APEX

BIG BRANCH 2 PUMP STATION

HAZEN CONTRACT NO. 32044-004
DATE: MARCH 2023

CIVIL
 ROADWAY PROFILE -
 SHEET 1

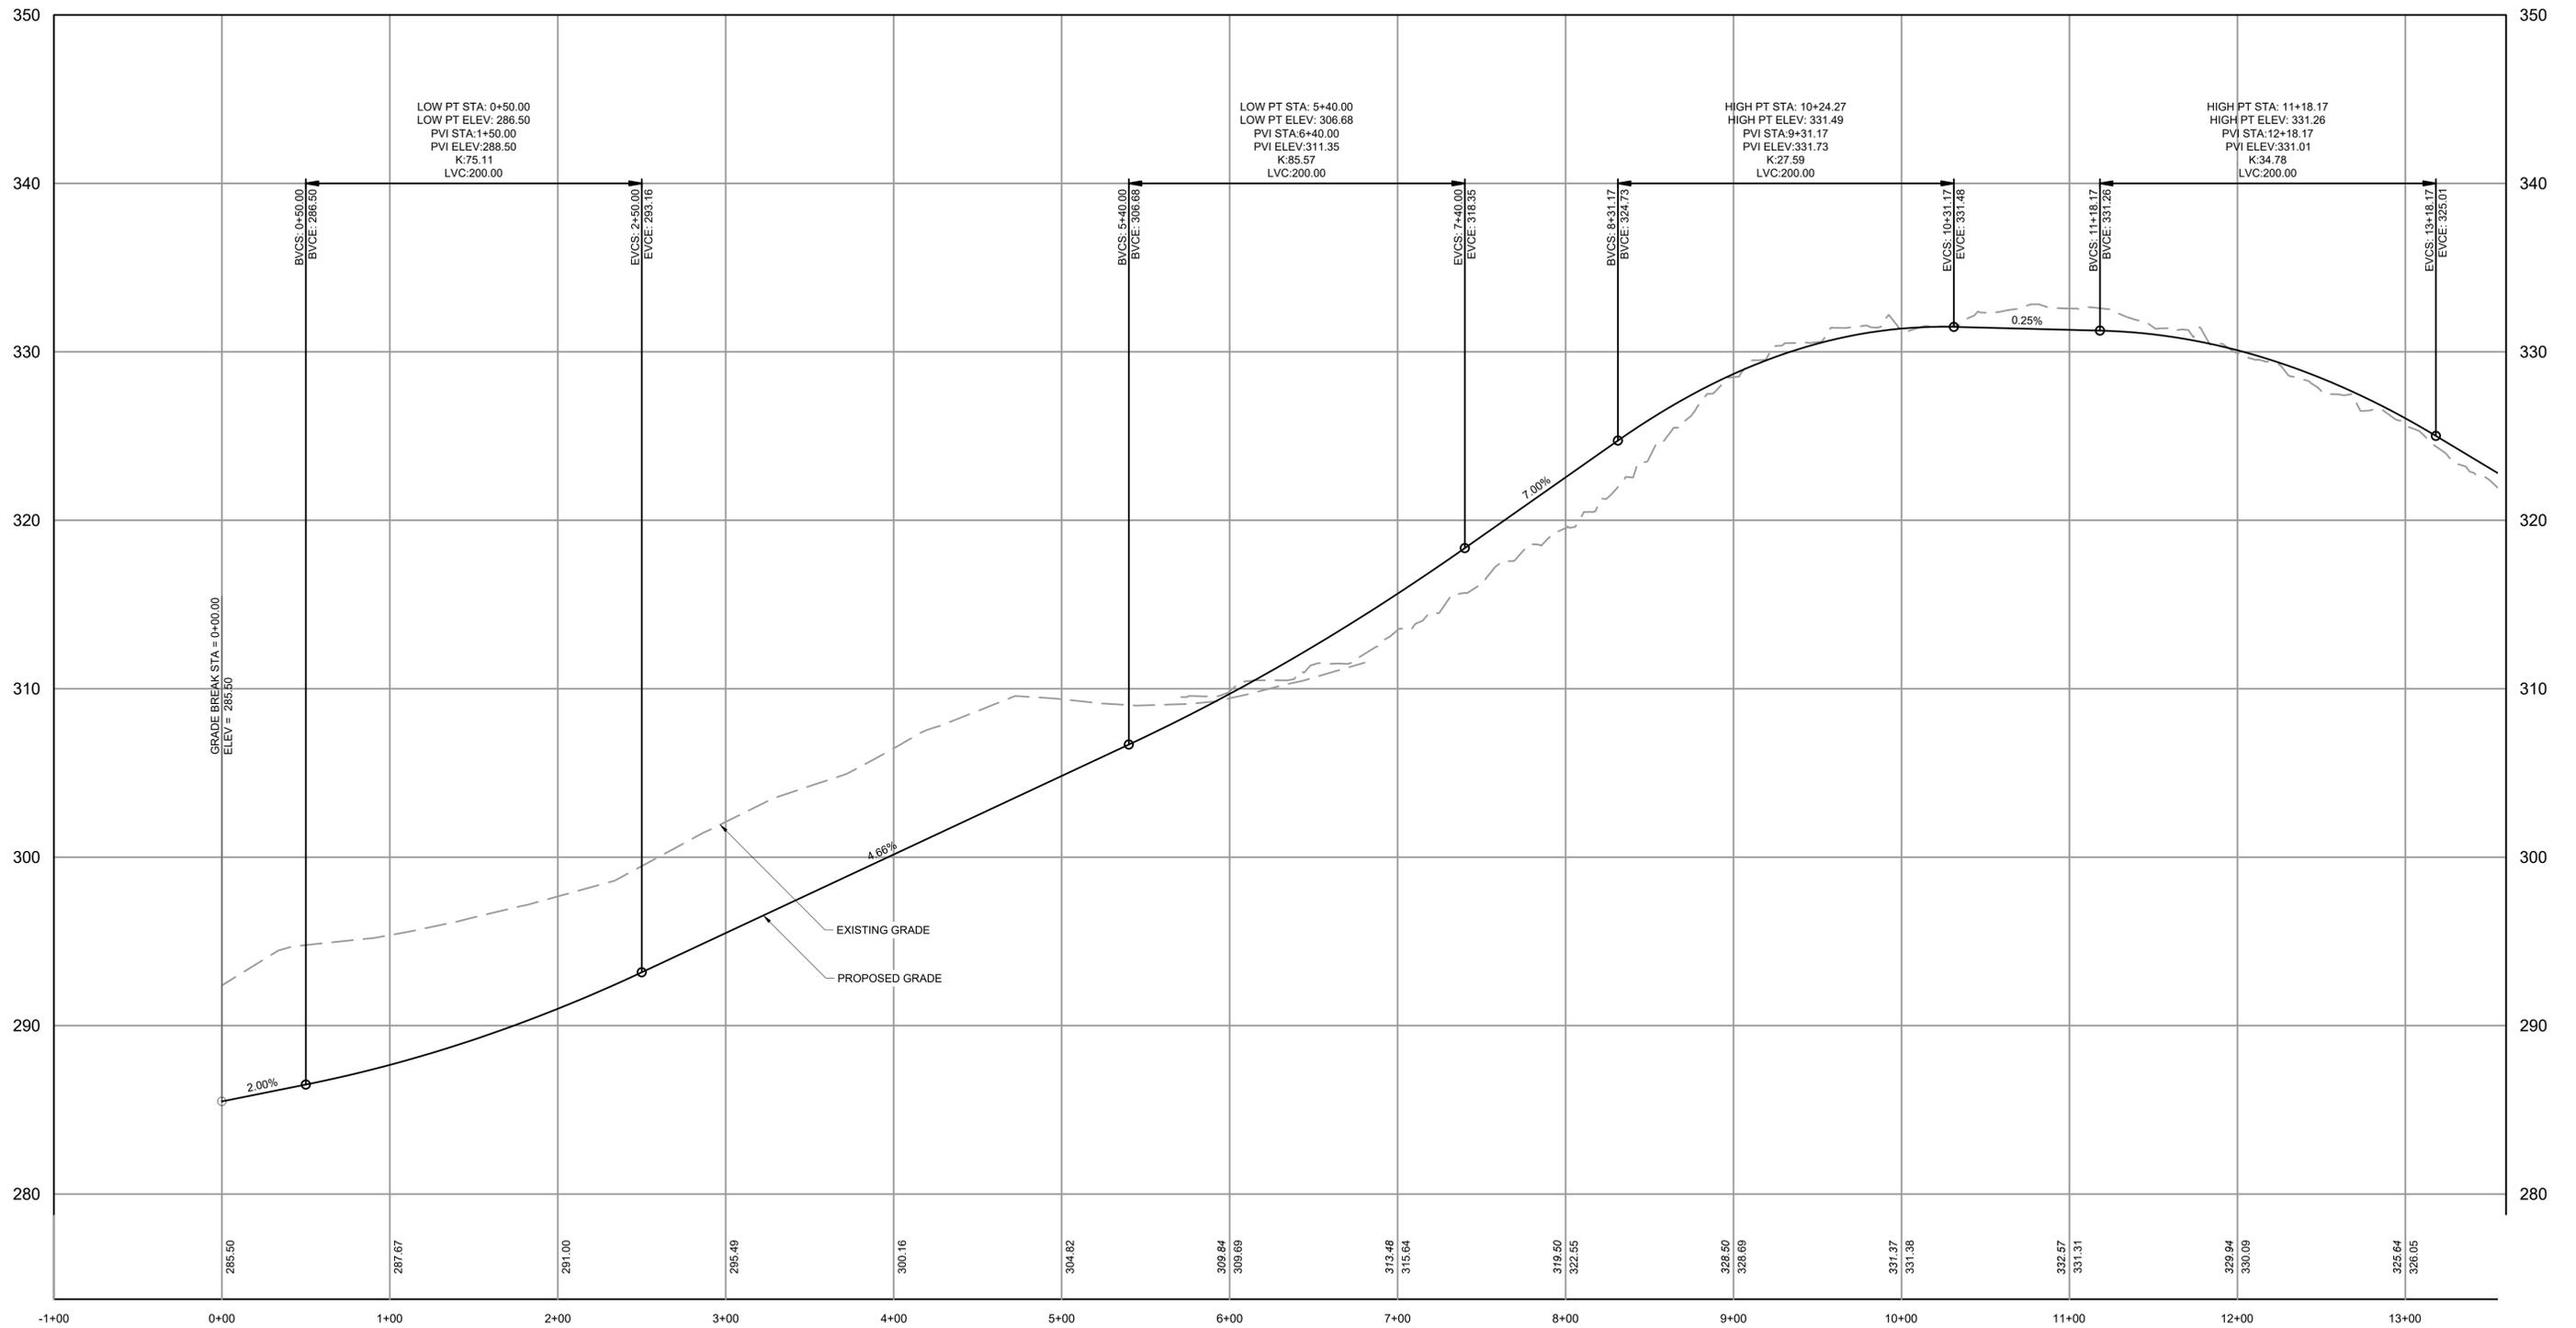
Will the water be designed with this project?
 Looking at this profile there will be some ARV's needed. Please provide profile for all water and sewer that you are proposing.
